1999 Ford Mustang GT V8-4.6L SOHC VIN X

## HOOD SCOOP - LOOSE OR DETACHED

01-17-4

BODY - HOOD SCOOP LOOSE OR DETACHED FROM HOOD

Figure 1

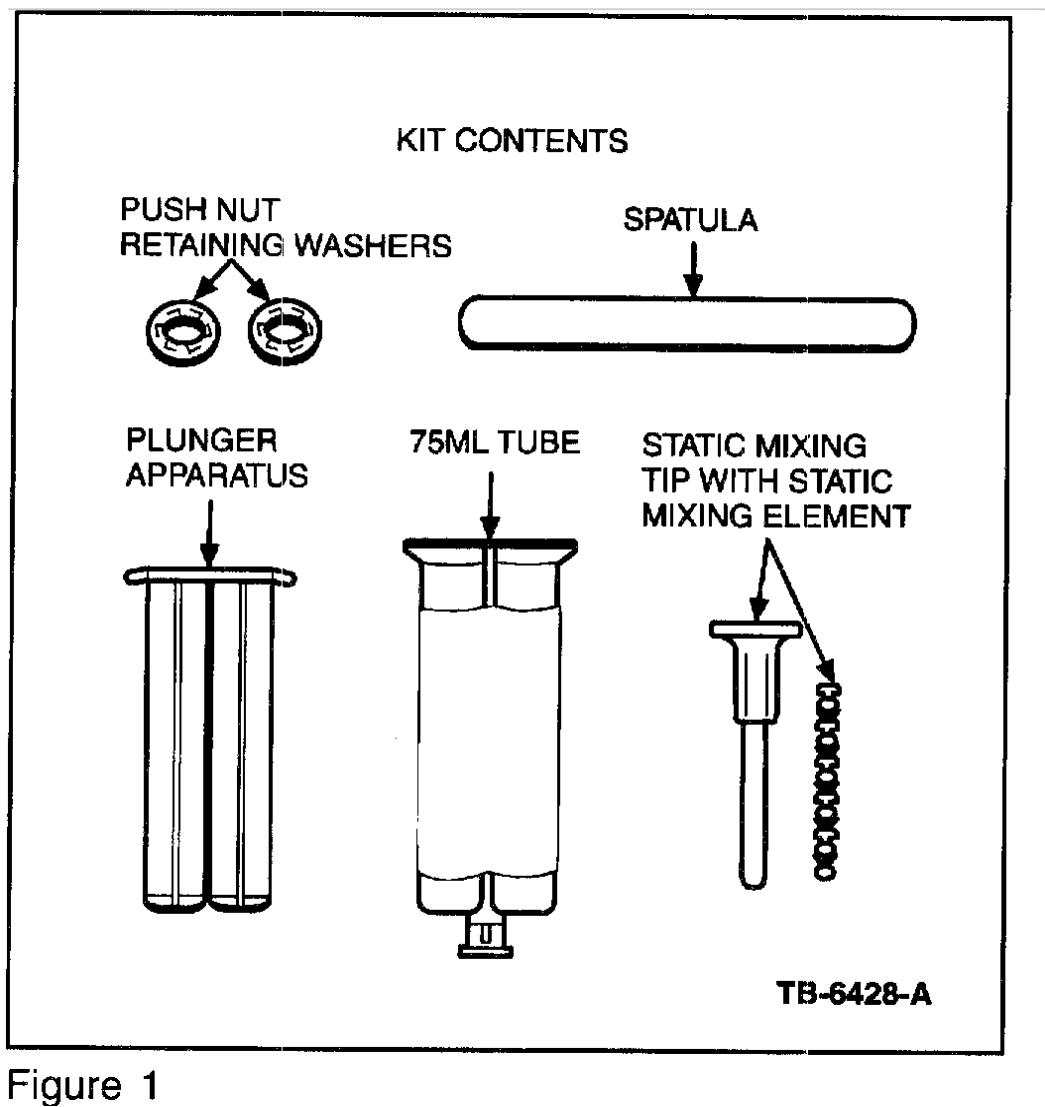
After obtaining the service kit 1R3Z-16C830-CPTM which contains the new hood scoop, 2 retaining washers, spatula, alcohol wipe, 75 ML tube of adhesive, and static mixing tip with static mixing element (Figure 1). Use the following procedure to replace hood scoop.

Figure 4

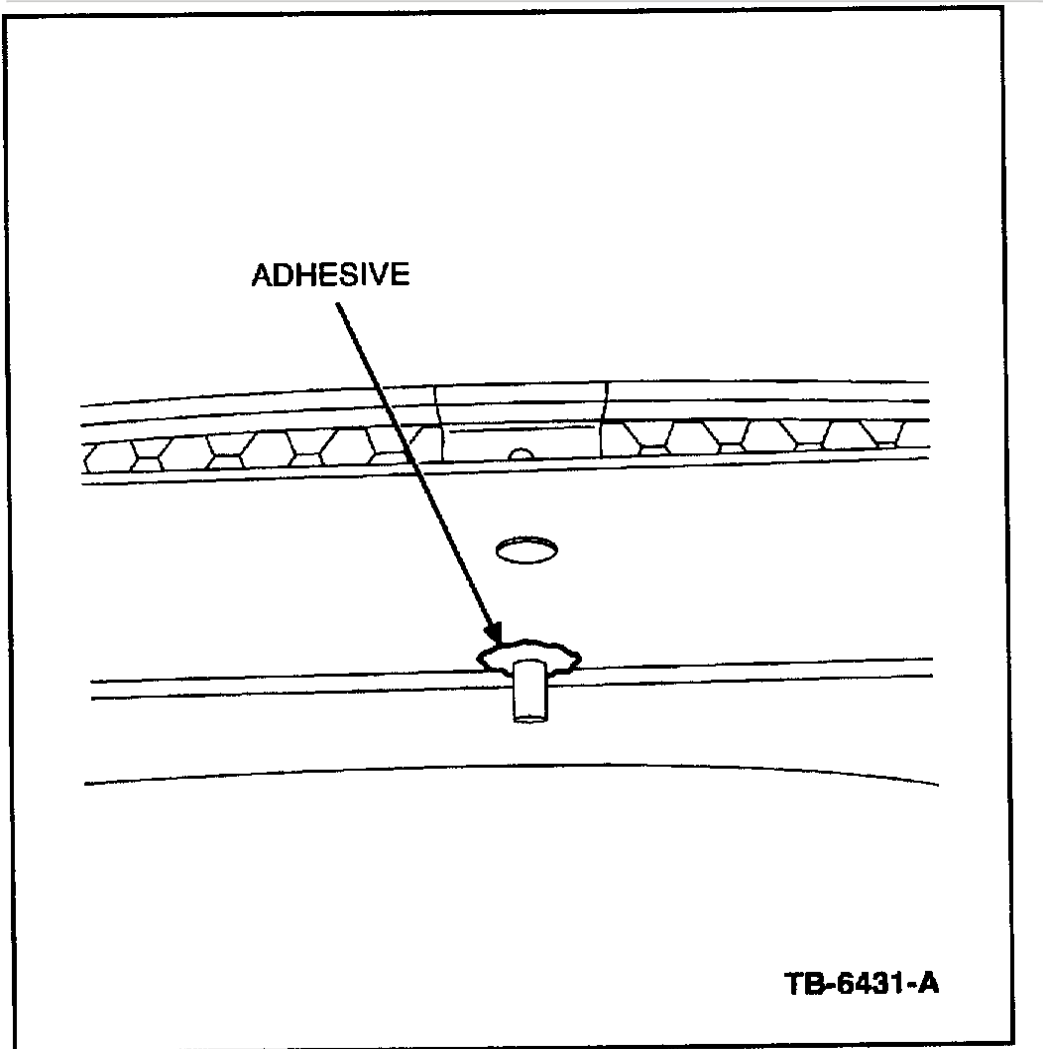
6. Apply adhesive to front and rear locator pins as show in Figures 4 and 5.
7. Apply adhesive onto neck of locator pins.
8. Remove red release paper from butyl adhesive tape and place hood scoop onto hood (Figure 5).
9. On underside of hood place adhesive around locator pins (Figure 4).
10. Using a deep socket wrench, press push nut retaining washers onto locator pins until hood scoop is fully secure and flush against the hood.

Figure 5

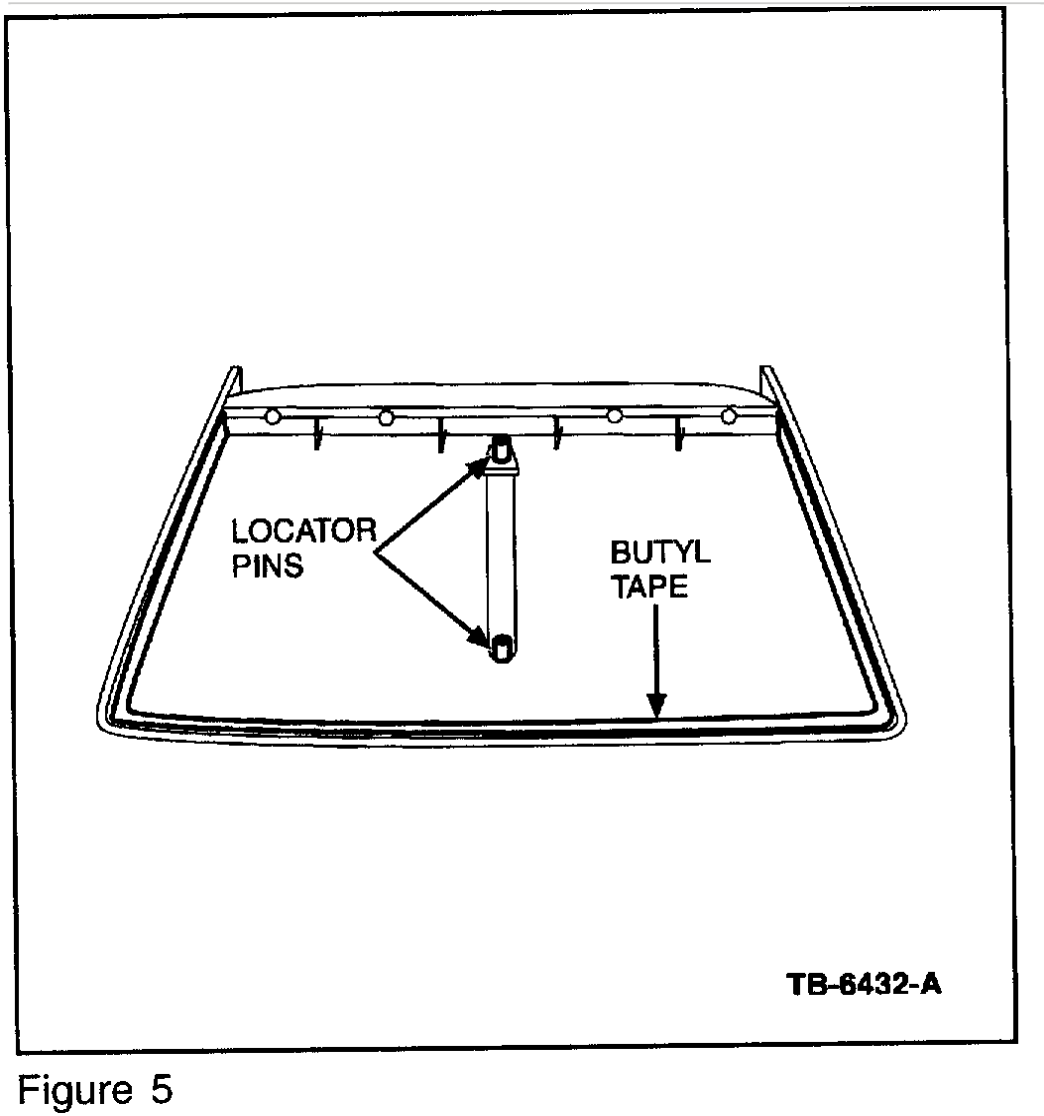
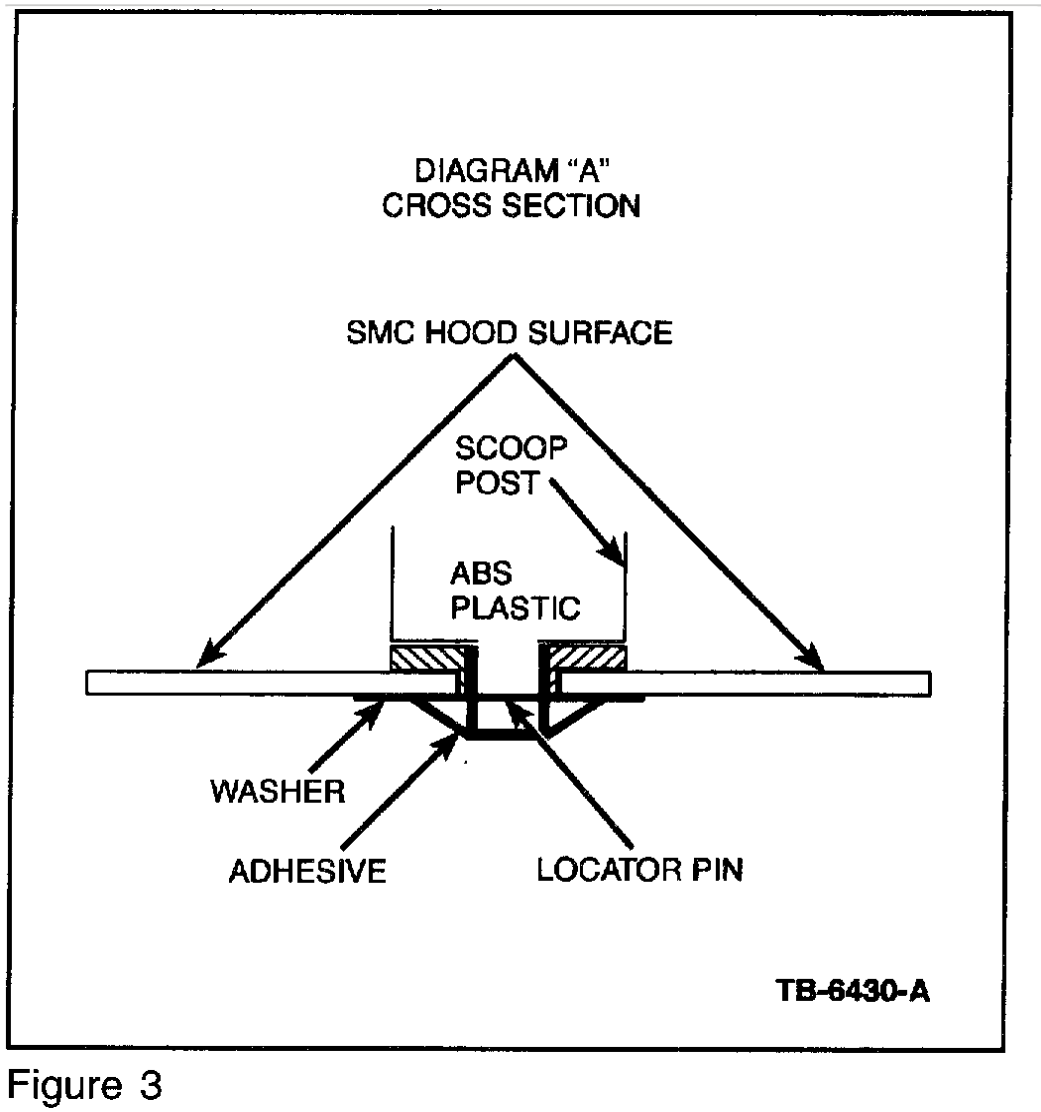
11. Apply adhesive onto both push nuts until they are entirely covered with adhesive (Figure 3).
